Ronald Stork
Friends of the River
1418 20th Street, Suite 100
Sacramento, CA 95814
(916) 4442-3155 x 220
rstork@friendsoftheriver.org

March 2, 2009

Re: Comments on Scoping Document 1, Pre-Application Document, Merced River Hydroelectric Project No. 2179-042

F.O.R Map prepared for 1991 Congressional testimony showing agency-proposed wild and scenic river/reservoir boundary — We understand that the MID parcel at the North Fork confluence just upstream of the project boundary was subsequently acquired by the BLM.

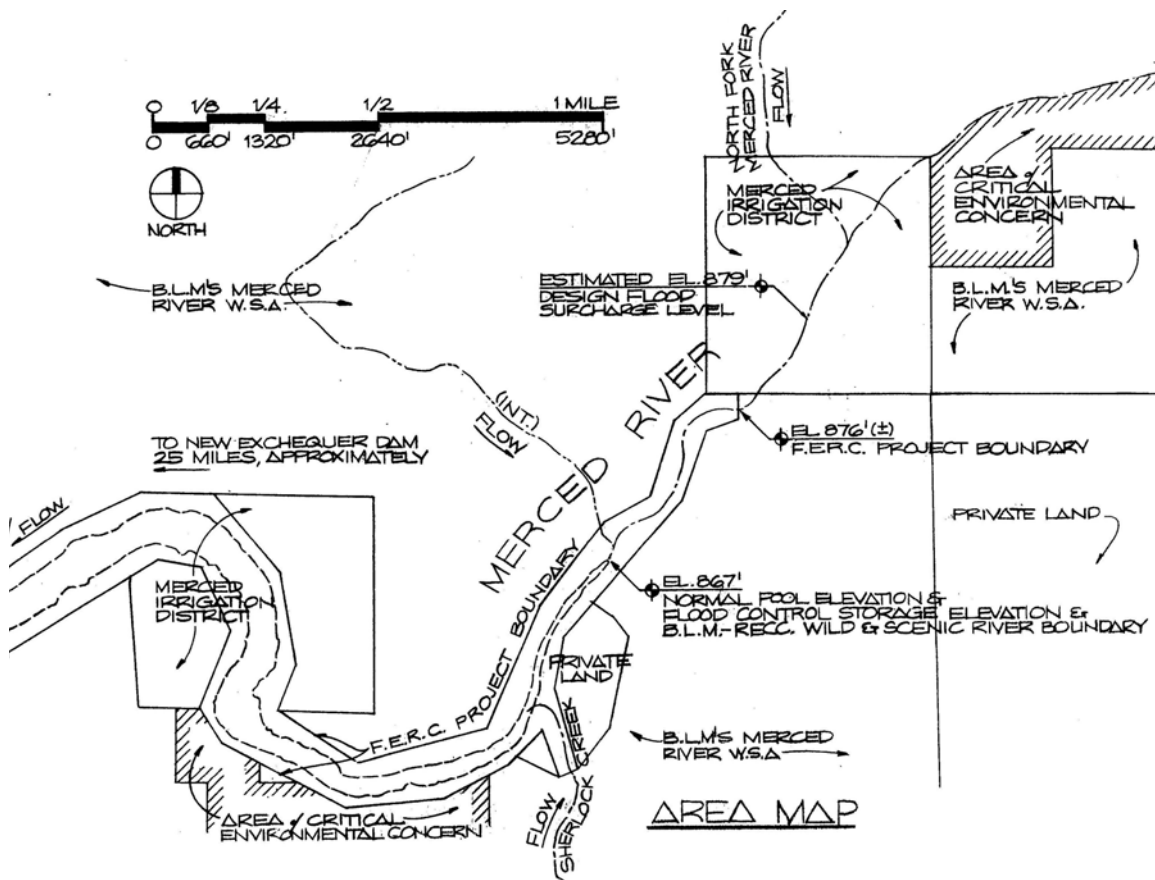
The joint agency policy was established in the Sierra National Forest’s 1986 draft land and resource management plan. This plan consolidated wild-and-scenic-river recommendations from all three federal agencies managing land along the river. Subsequent BLM planning documents reaffirmed the earlier agency boundary policy. The agency recommendations were embodied in the Congressional action designating this reach of the Merced in 1992, and shown on the following map presented by Friends of the River in Congressional testimony.

The wild-and-scenic-river managing agencies recommended establishing the wild-and-scenic-river/reservoir boundary at the upstream river location corresponding to the elevation of the ungated spillway of the dam (in this specific case, the nominal “normal pool” of the reservoir). The agencies took the view that this was the location on the river where the FERC-licensed project works no longer impound a reservoir “on” or “directly affecting” a wild and scenic river. They took this view because above this point a dam lacks the operational capacity to *store* water, the conventional definition of a reservoir. Their view was embodied in the legislation passed by the Congress. In the view of the agencies and the Congress, below this point the District has (if Providence provides) the ability to conduct any reservoir storage or release operations consistent with the FERC license, Corps of Engineers reservoir regulation manual, Endangered Species Act compliance, state water rights, its agreements, or other provisions of law.
